City of Santa Fe, New Mexico

DATE: 13 February 1996
TO: Historic Design Review Board Members
FROM: Mary Grzeskowiak, Planner III
Heather Pierson, Planner II *HP*

CASE #H-96-24 ADDRESS 1295 Cerro Gordo Road

Re: Addition and remodel of home in Eastside Historic District for Roberta Armijo at 1295 Cerro Gordo.

Addition for Roberta Armijo
1295 Cerro Gordo

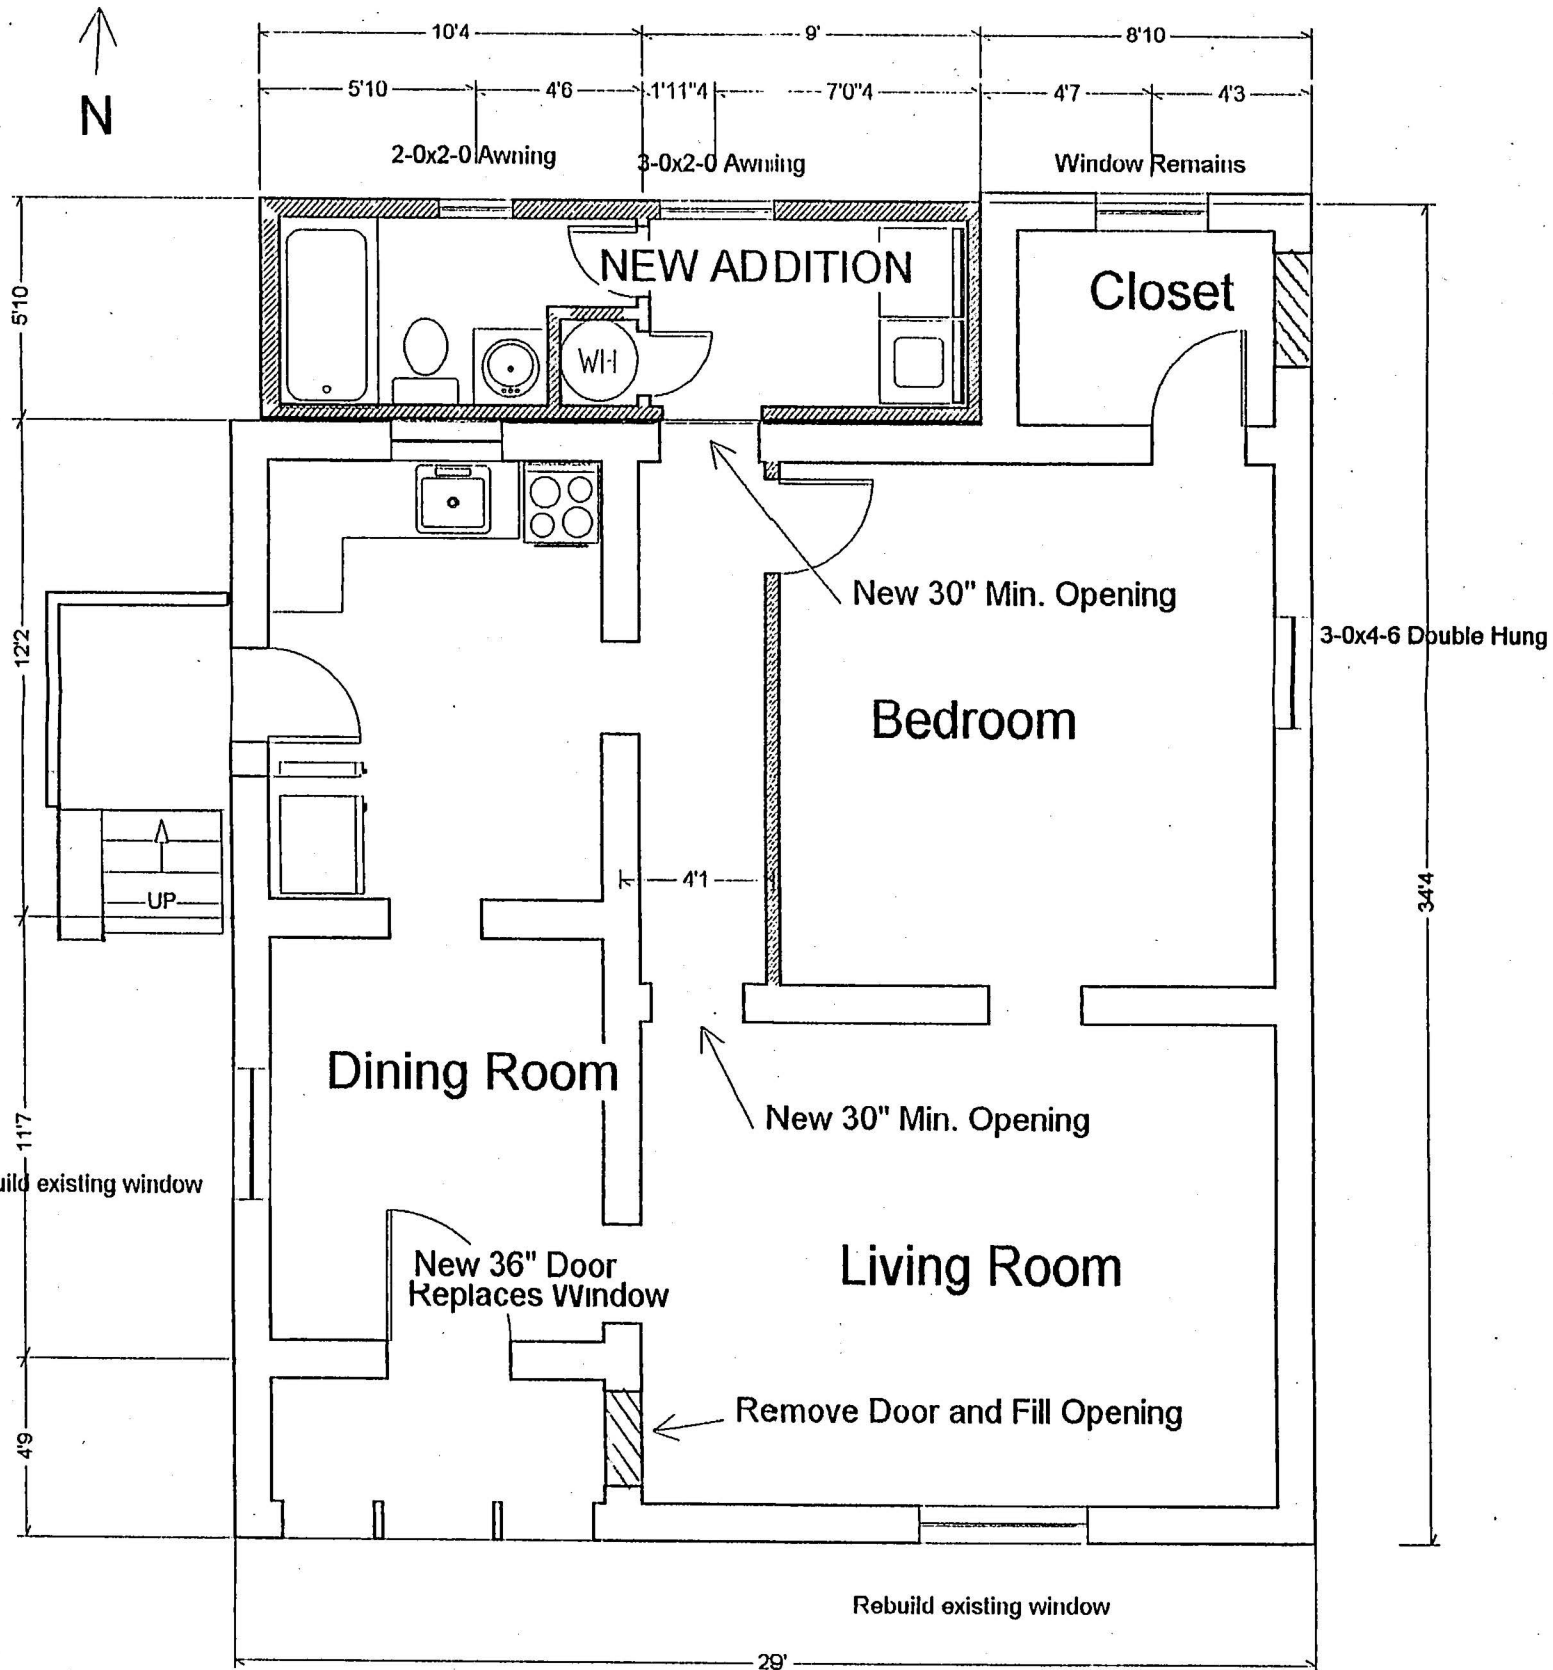
- 1) A 6'x19' bathroom/laundry addition at the rear of the house and rearrange floor plan.
- 2) Replace south dining room window with a 36" wood and glass door (originally there was a door here that was removed). Remove existing front door (this was a later addition that was installed when the door to the dining room was removed) and fill-in. See attached letters.
- 3) Rebuild west dining room window and living room window.
- 4) Replace bedroom window with Marvin or equal metal clad wood double hung window that meets fire egress standard. Color to be brown.
- 5) Remove existing exterior side door from closet and stucco over.

- 6) Remove shed roof section on closet and reroof as flat.
- 7) Restucco entire house in earthtone color (El Rey "Desert Rose").

SOUTH 1/4" = 1'-0"
VIEW FROM STREET

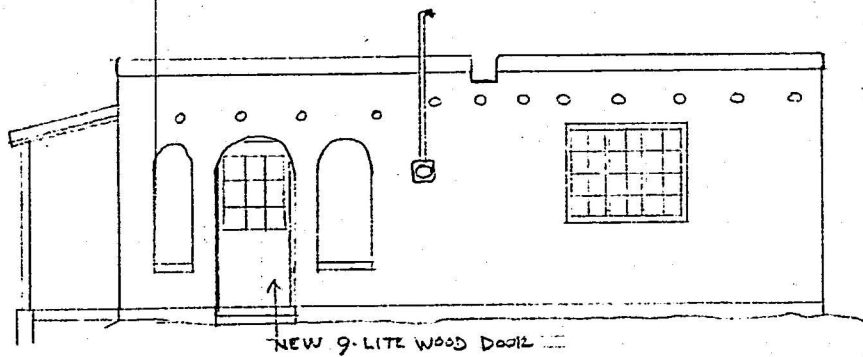
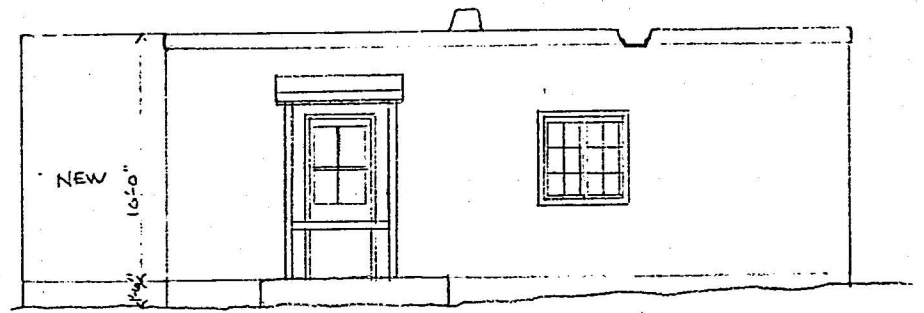
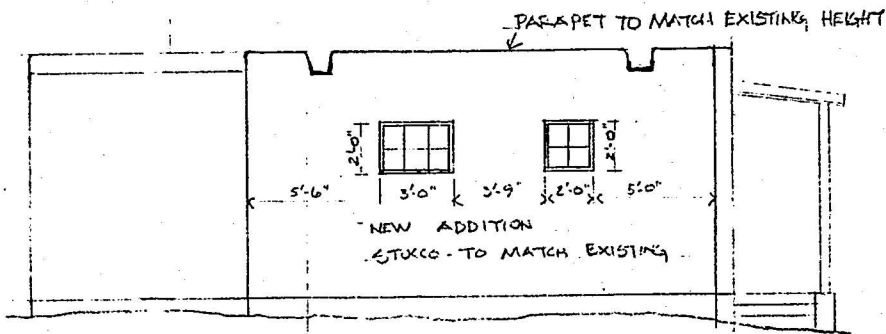
The applicant has provided illustrations for a 115 square-foot addition on the north elevation (rear) of an existing 812 square-foot residence on the subject property. The scope of work includes the addition, rearranging the interior spaces, reopening a historic entry under the portal on the south elevation, closing a non-historic entry in the same area, replacing a window on the east elevation to comply with egress requirements, and closing a door opening on the east elevation. Proposed stucco color will be El Rey *Desert Rose*, trim color is to be *Cool Lagoon*, and clad window color will be *Toffee Crunch*. Replacement and addition windows will be Marvin brand divided-lights. Historic casement windows on the west and south elevations are to be restored. Finally, the shed roof on the closet will be replaced with a flat roof to match the rest of the structure.

Staff acknowledges design standards for the Downtown and Eastside Historic District have been met. Staff also acknowledges the applicant's efforts to comply with preservation standards. The applicant will be restoring historic window units, and Staff commends the applicant's efforts to preserve such historic features (Section 14-70.73E1a 1987 SFCC). The applicant has also provided substantial documentation as to the previous existence of an entryway on the south elevation, therefore, Staff is not concerned with the proposed changes on this elevation (Section 14-

70.73E1b and 14-70.73E2 1987 SFCC). The addition will be placed to the rear of the historic structure, therefore complying with preservation standards as to the placement of additions (Section 14-70.73B4 1987 SFCC). Staff encourages that the addition's parapet be 6 inches lower than that of the historic structure so the addition can be differentiated from the historic structure. Pending resolution of this concern and determination of the appropriateness of the color scheme proposed, Staff recommends approval.
